02/05/09 ROADWAY DESIGN STAFF MEETING
Roadway Design Unit Conference Room
9:00 a.m. – 11:00 a.m.

SUBJECT: Median U-Turn Bulbs

DATE: February 5, 2009

DIRECTIONAL CROSSOVER WITH MEDIAN U-TURNS

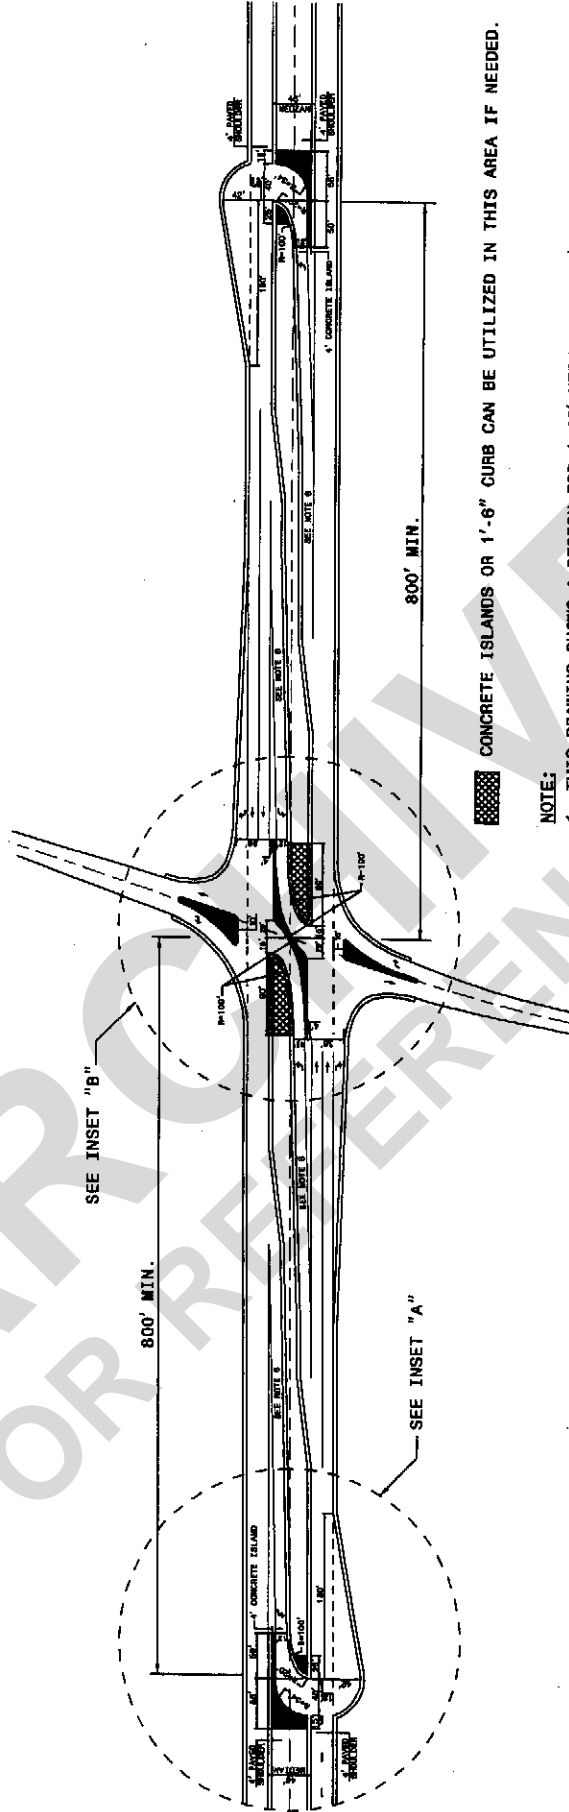
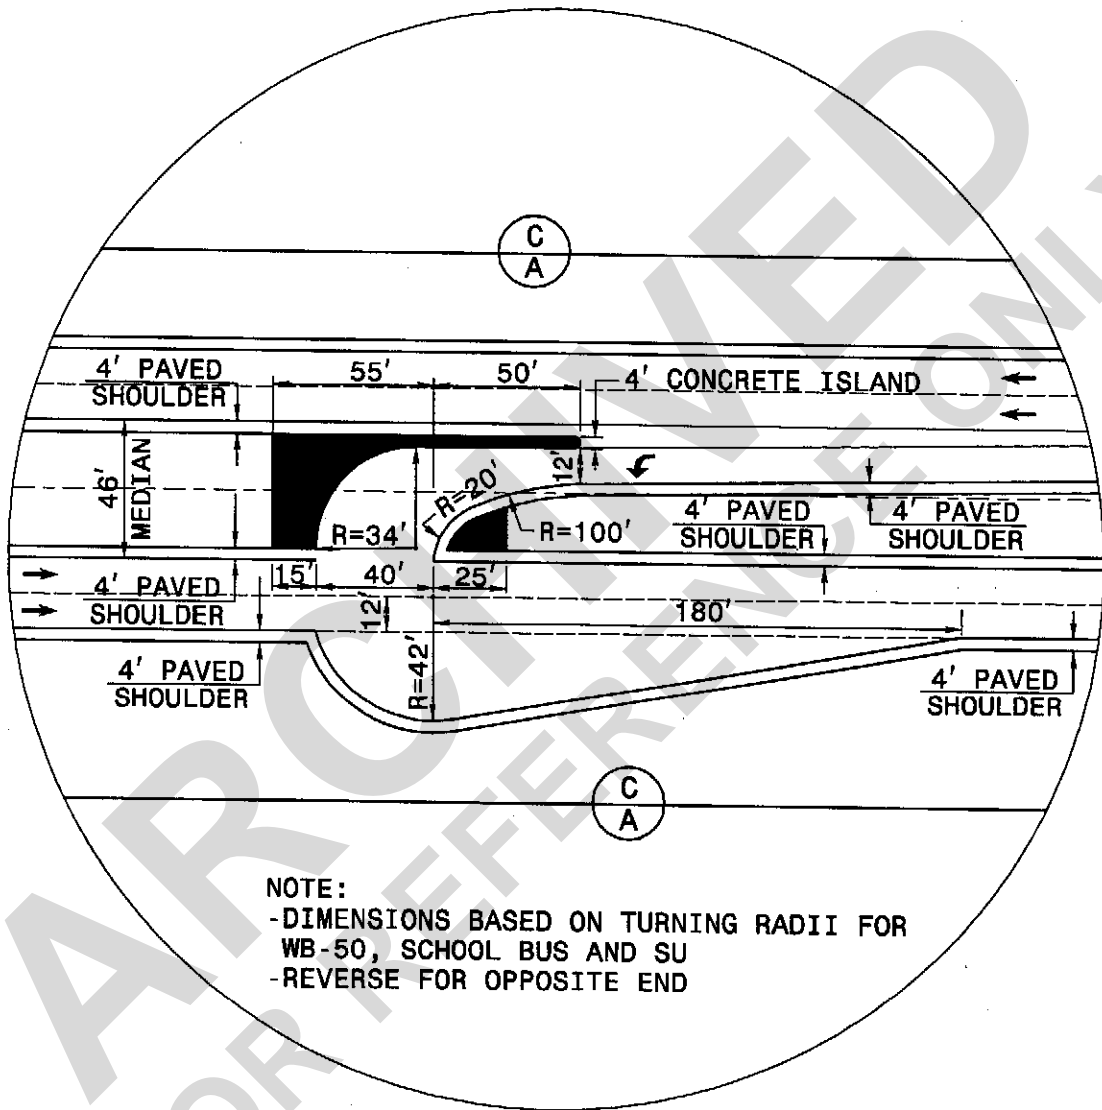
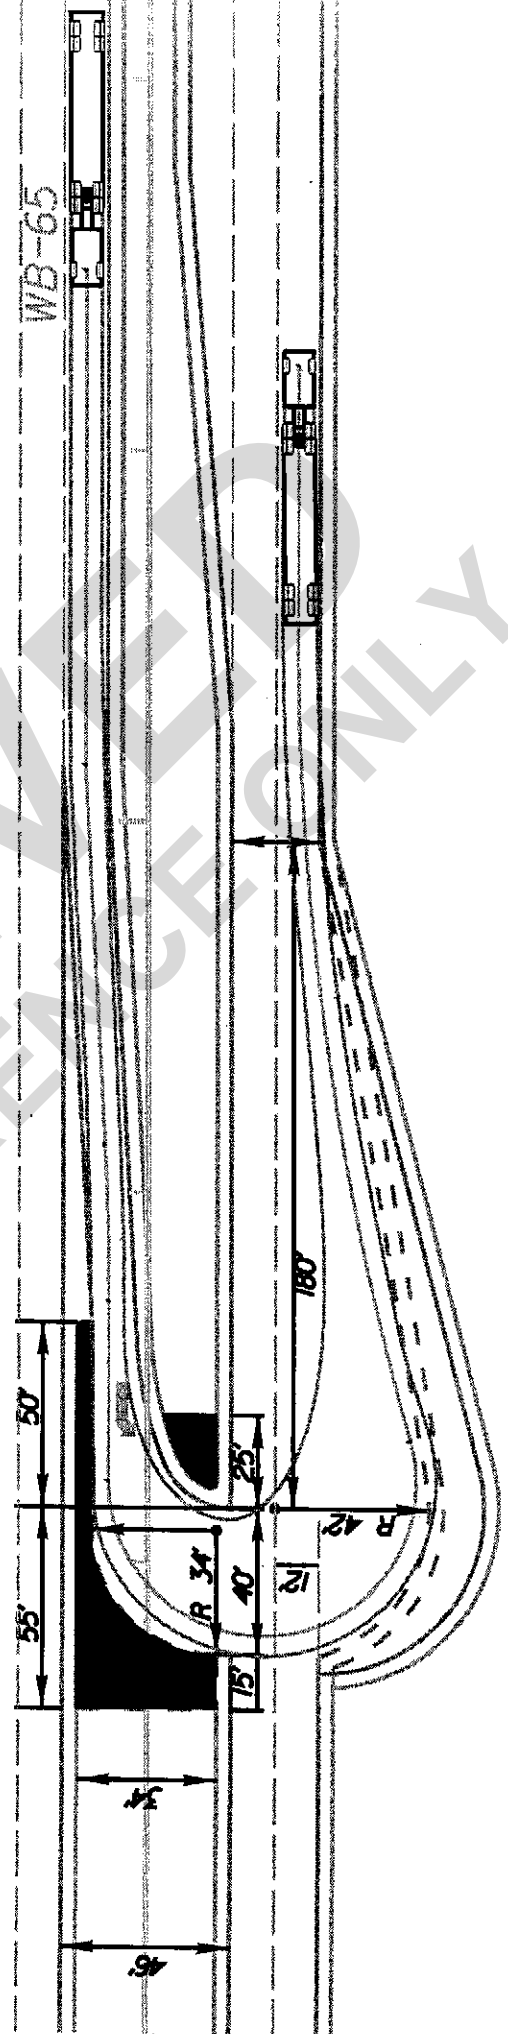
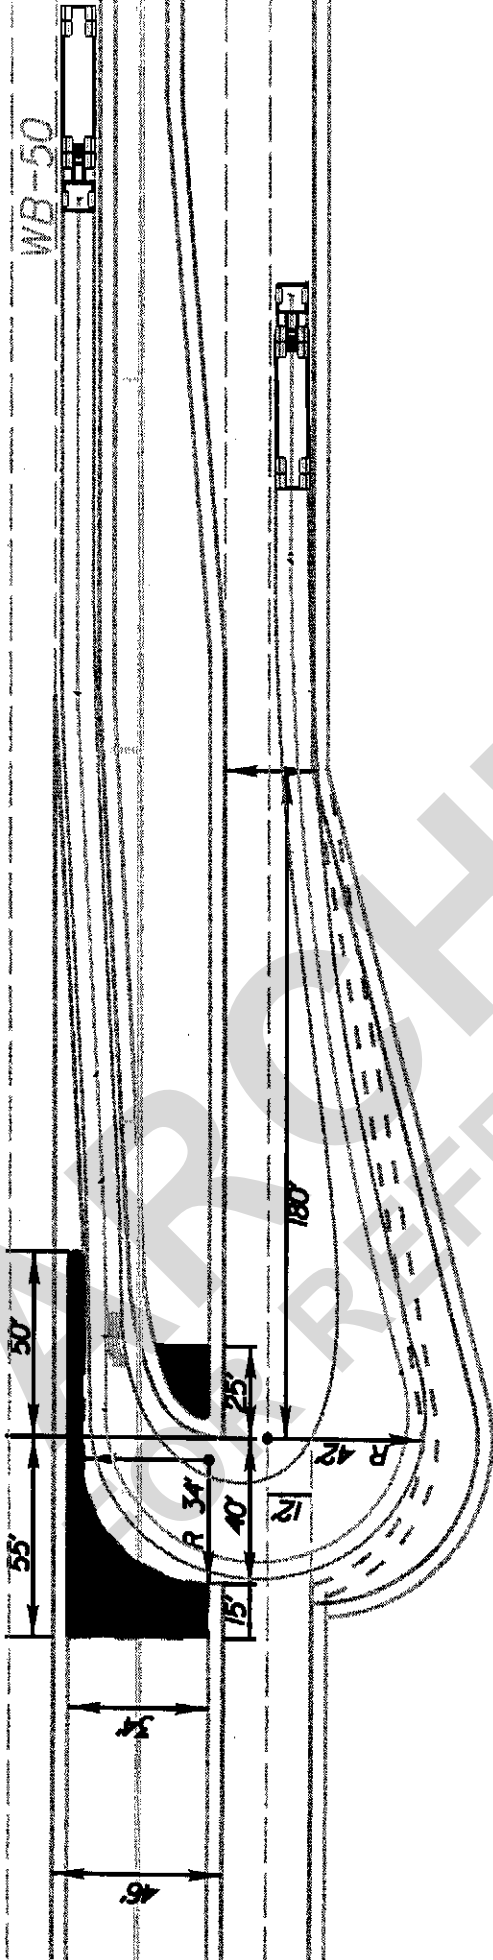
In an effort to reduce right of way impacts and minimize costs, the median U-turn bulb-out design for a 46' median has been revised.

The revised design reduces the bulb radius to 34' and modifies the configuration of the concrete island. A turning vehicle may need to use the 4' paved shoulder to complete the turn. This design will accommodate WB-50 and WB-65 design vehicles.

Plans that will be submitted for right of way acquisition on June 19, 2009, and beyond should incorporate this update. Design changes for other projects will be evaluated on a case-by-case basis. Please discuss the need to incorporate these changes with the Division Construction Engineer or Resident Engineer. If you have any questions regarding this information, please contact Jay A. Bennett, PE at 919-250-4016.
